# Access Compliance Report

## Public Rights-of-Way

### (Curb Ramps)

Intersection ID: 10015635	Main Street: HARRIS_CORNERS_PY	Cross Street: N/A	Location: NE
ADA ID: 76AEDD72A3AE	Ramp Type: Perp	Initial Pass/Fail: Fail	Overall Compliance: No
Severity Score: 25			
Codes/Mitigation Info/Possible Solution		Field Measurements/Component Compliance

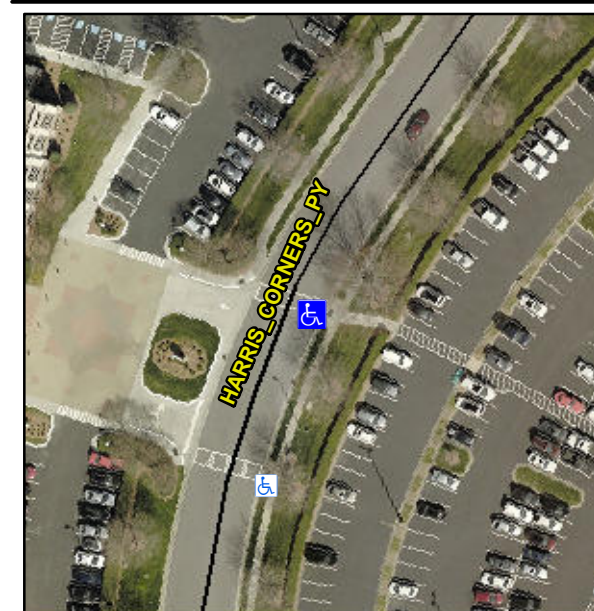
**Not Found, R304.2.2**

Compliance	Description	Data	Compliance	Description	Data
N/A	Ramp Length (in)	46.0	No	Ramp Slope (%)	14.6
Yes	Ramp Width (in)	48.0	Yes	Ramp XSlope (%)	0.7
N/A	Flare Type LT	N/A	N/A	Flare Type RT	N/A
N/A	Flare Slope LT (%)	N/A	N/A	Flare Slope RT (%)	N/A
N/A	Flare Traversable LT?	N/A	N/A	Flare Traversable RT?	N/A
N/A	Landing Length (in)	N/A	N/A	DWS Provided?	N/A
N/A	Landing Width (in)	N/A	N/A	DWS Contrast?	N/A
N/A	Landing Slope (%)	N/A	N/A	DWS Length (in)	N/A
N/A	Landing X Slope (%)	N/A	N/A	DWS Full Width?	N/A
N/A	Landing Curb? (Y/N)	N/A	N/A	DWS Offset (in)	N/A
N/A	Shared Landing?	N/A			
N/A	Gutter Ponding?	N/A	N/A	Gutter Slope (%)	N/A
N/A	Gutter Lip Ht (in)	N/A	N/A	Gutter X Slope (%)	N/A
N/A	Painted X Walk1?	Yes	N/A	Painted X Walk2?	N/A
	X Walk 1 Direction	To NW		X Walk 2 Direction	N/A
N/A	X Walk 1 Width (in)	89.0	N/A	X Walk 2 Width (in)	N/A
	X Walk 1 Slope (%)	0.0		X Walk 2 Slope (%)	N/A
	X Walk 1 X Slope (%)	0.2		X Walk 2 X Slope (%)	N/A

**Remove & Replace Entire Ramp.**
